New England Solar Farm (SSD 9255)

COMMENTS ON PROPOSED CHANGES TO CONDITIONS – NEW ENGLAND SOLAR (SSD 9255)

Figure 1 – Viewshed analysis (Source Appendix I – Landscape and Visual Assessment)

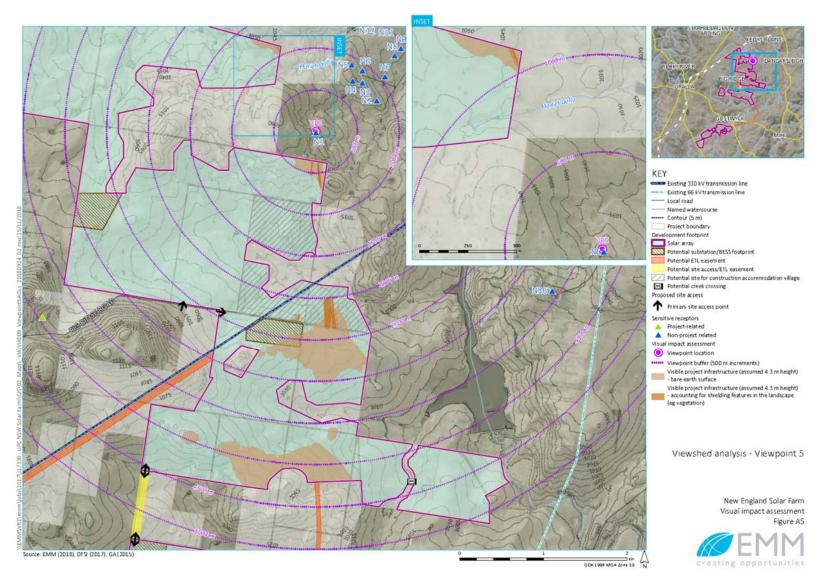
The visual impact assessment prepared by the applicant in the EIS provided a viewshed analysis (see **Figure 1**). The Department notes that this viewshed was prepared on the basis of the layout proposed in the EIS which had the array located 350 m from the residence but was later amended by the applicant to set back the solar array 450 m from the residence.

The viewshed analysis (prepared for the project infrastructure and included consideration of shielding features in the landscape such as vegetation) showed a small confined area to the south of the residence where infrastructure would be visible.

The Department notes that this is in contrast to the proposed change which requires landscaping along the entire length of the southern boundary with the development to screen views from the property (rather than the residence and curtilage).
